Bayswater Water and Other Associated Operational Works Project
Environmental Impact Statement Response to Submissions Report

IS353800_RtS | Final

AGL Macquarie Pty Ltd

- | | | |

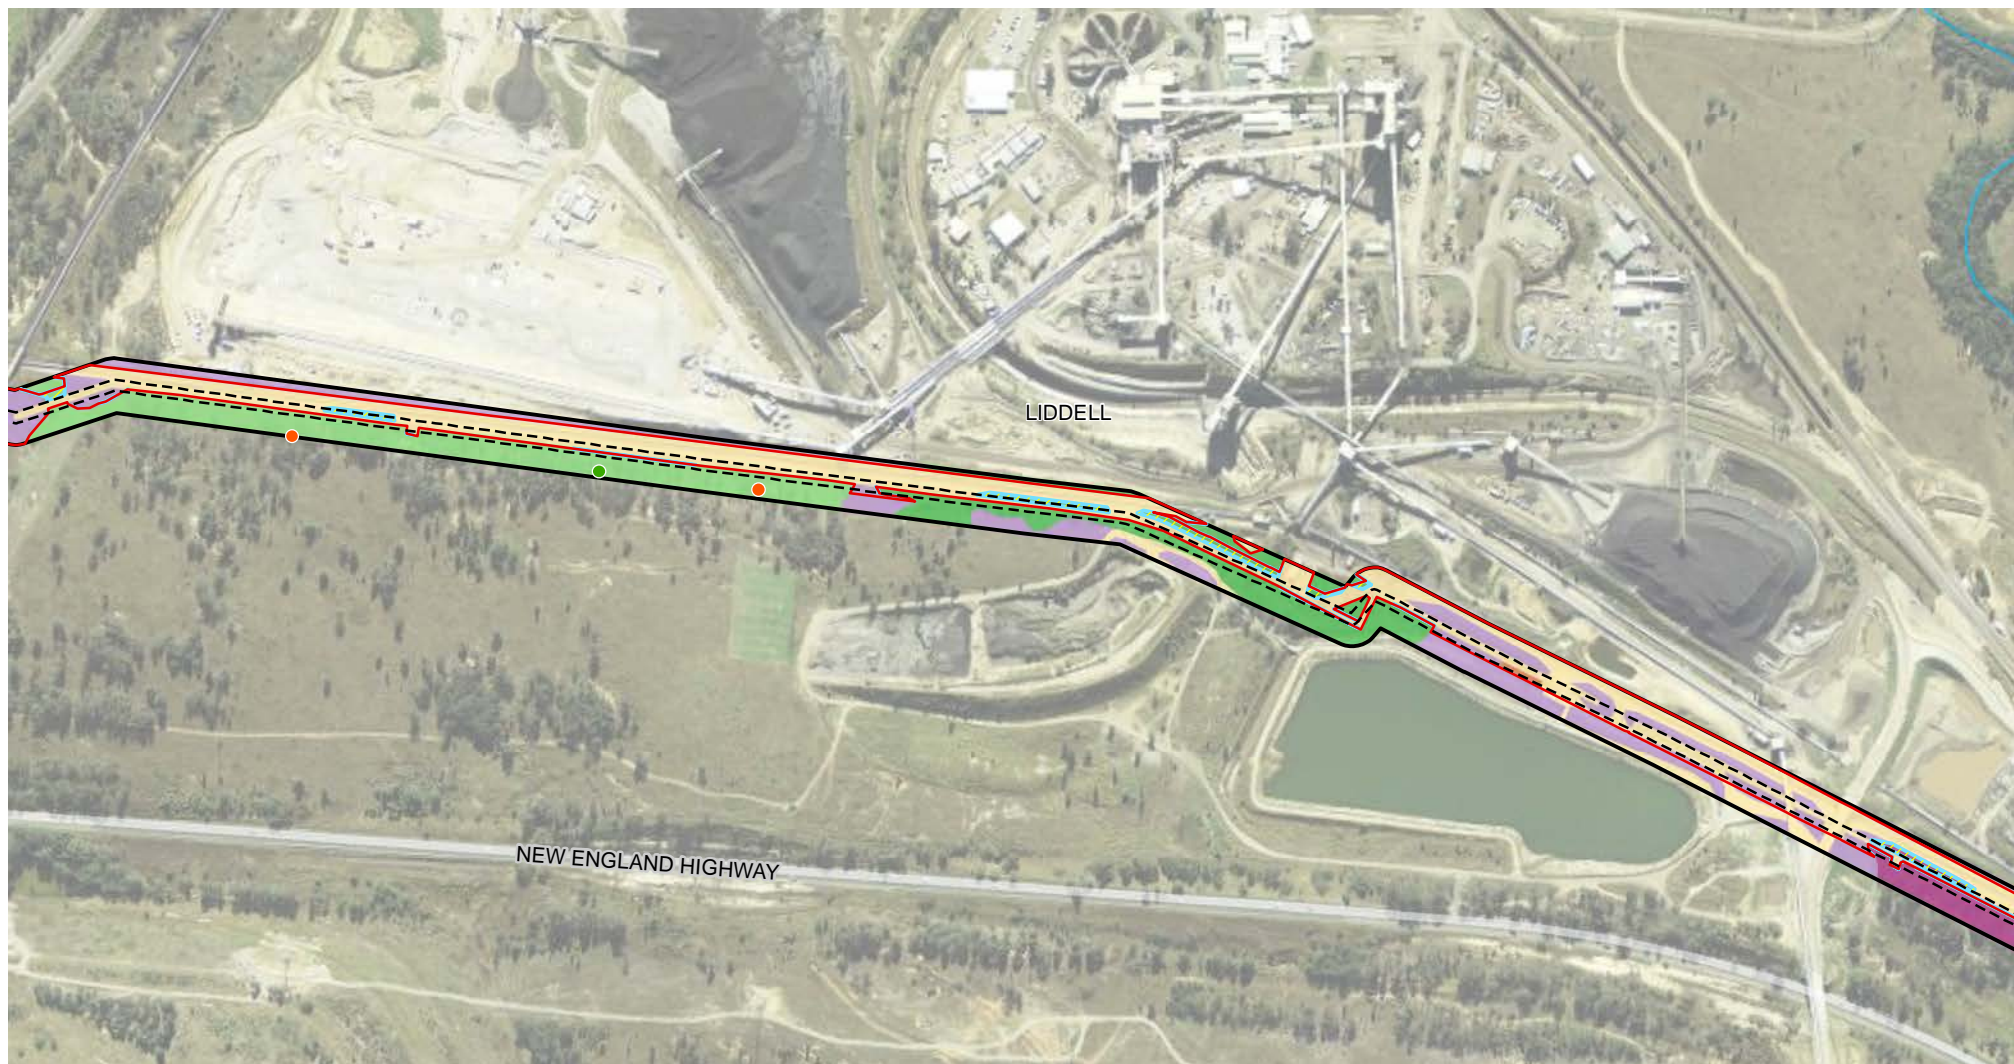
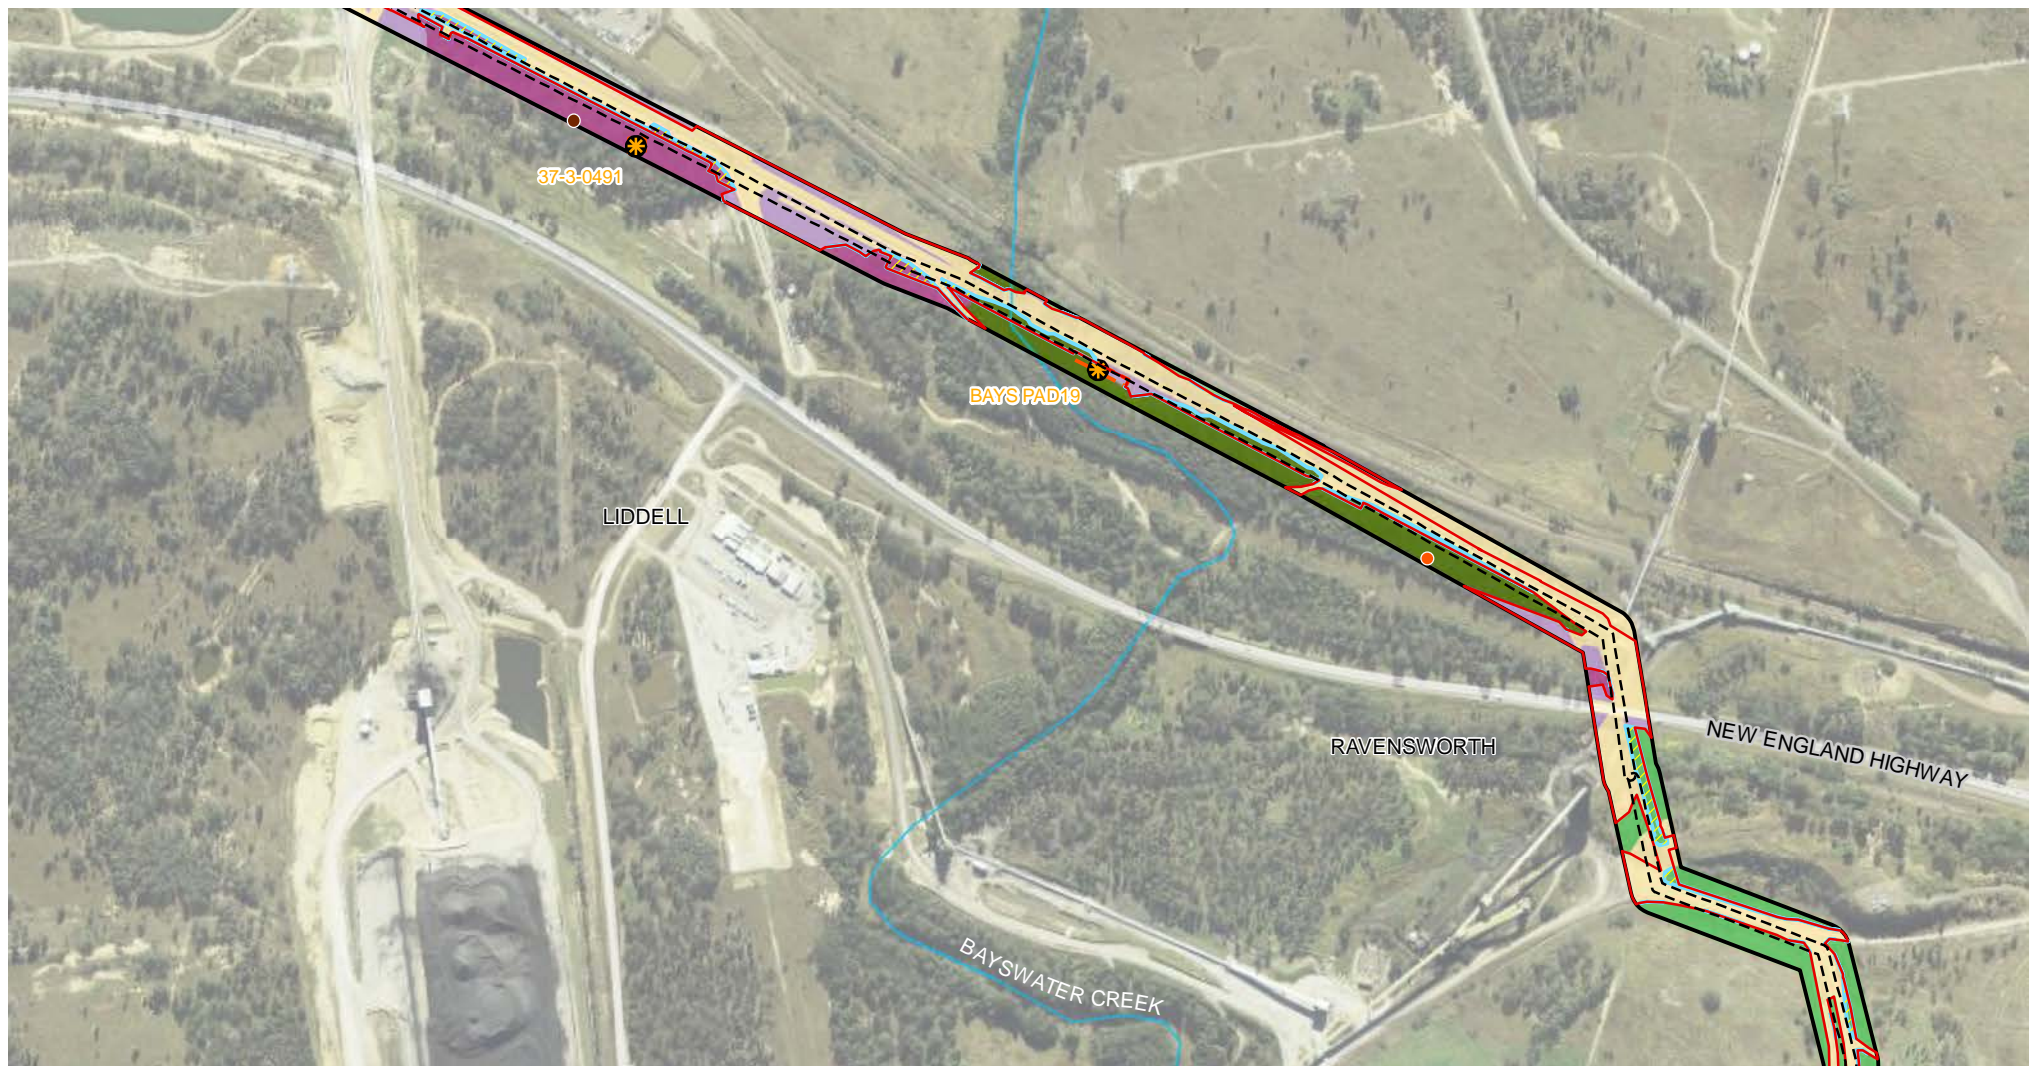
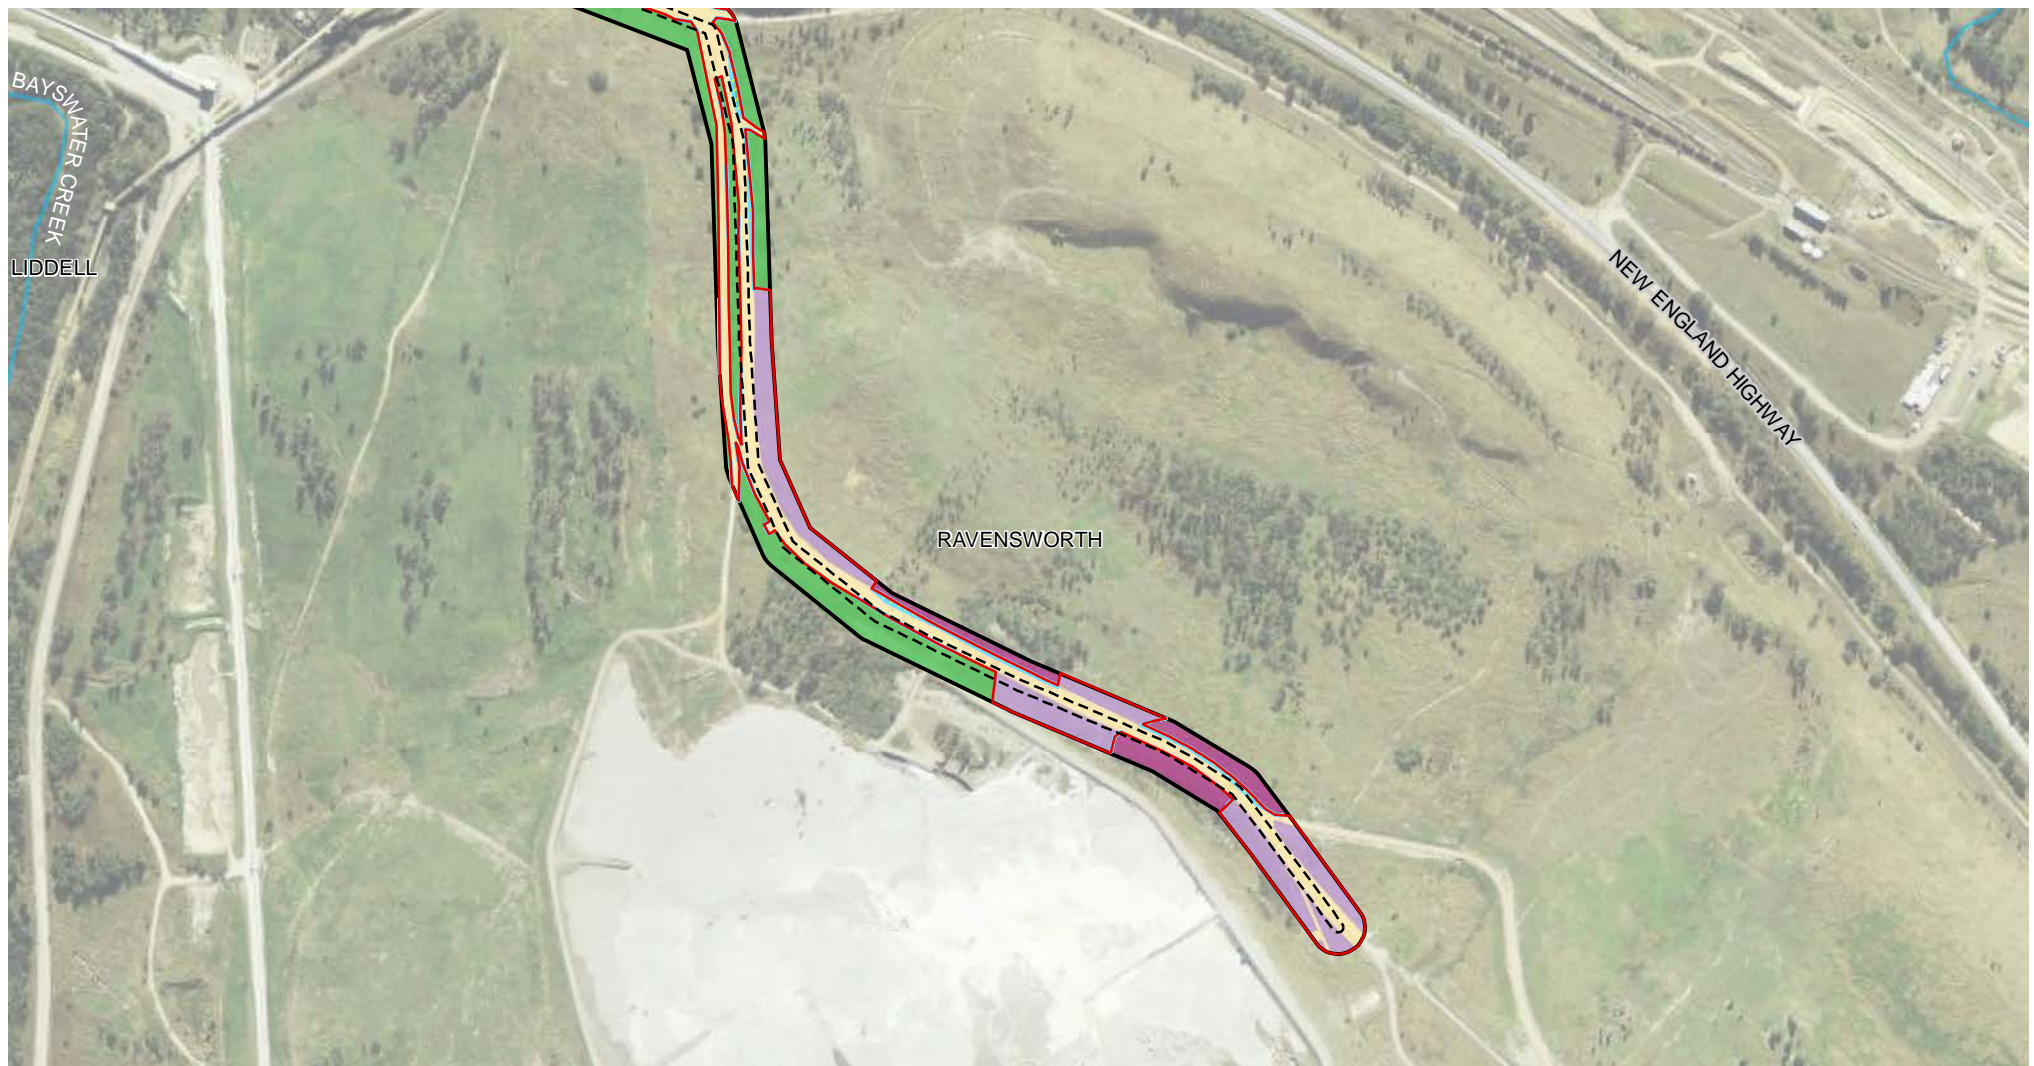
- More than one pipeline may be an option for final design noting that the existing Ravensworth pipeline consists of two adjacent pipelines and the new wording is added for completeness

- Impacts on 200.64 hectares (**ha**) of Plant Community Type (**PCT**) 1691, generating a credit obligation of 3780 ecosystem credits (reduced from 206.82 ha and 3,904 credits)

- Impacts on Paddock Trees associated with PCT 1691 requires a total of 31 ecosystem credits (no change)
- Impacts on 55.08 ha of Squirrel Glider habitat, generating a credit obligation of 1346 species credits (reduced from 59.05 ha and 1,433 credits)

- Impacts on 8.11 ha of Southern Myotis habitat, generating a credit obligation of 233 species credits (no change)
- Impacts on 116.74 ha of Striped Legless Lizard habitat, generating a credit obligation of 2,102 species credits (reduced from 120.68 ha and 2169 credits).

Figure 5 - 1 Singleton Shire land ownership project interaction at Pikes Gully Road

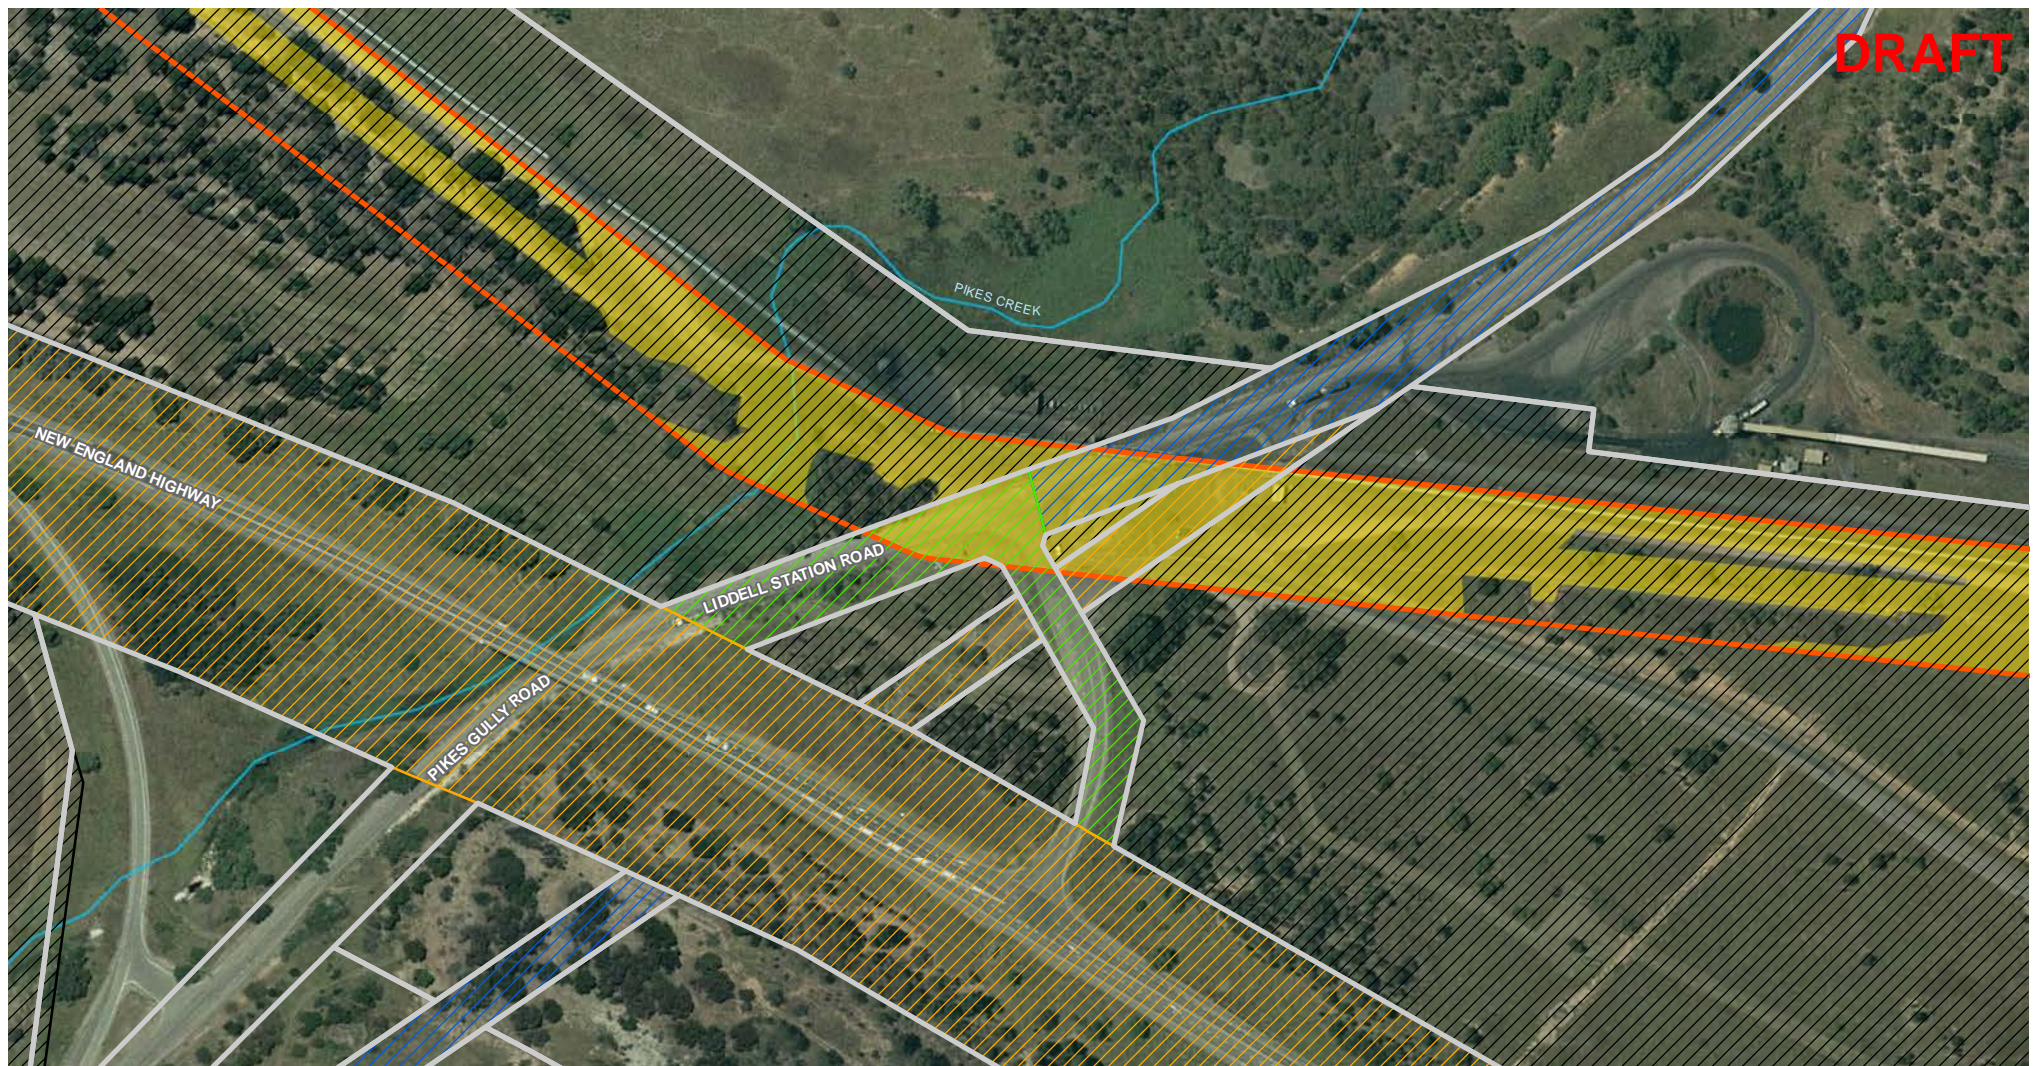
Singleton Council Submission item/issue raised	AGLM Response
<p>Comments on the Project</p> <p>The EIS provides little detail as to how Project component activities will be synergised across the two Local Government Areas, particularly in relation to rehabilitation planning and decommissioning.</p> <p>Consideration should be given to the LEP objectives of the zone noting that Council agrees the development is not inconsistent with these objectives.</p>	<p>Details of synergies across the LGA boundary were not provided on the basis that while two LGAs are affected by the Project and ongoing operation of Bayswater, AGLM does not approach site planning and management with a focus on the different LGAs. The EIS has considered permissibility within each LGA and all components are permissible. Rehabilitation and decommissioning planning will be approached consistently across the LGA boundary.</p> <p>Singleton LEP objectives for the RU1 Primary Production zoning that applies were documented in Section 3.4.7 EIS and the Project considered compatible. The basis of the consideration was that the Project does not introduce land use conflicts or fragment resources lands as documented in Section 4.4 of the EIS.</p>
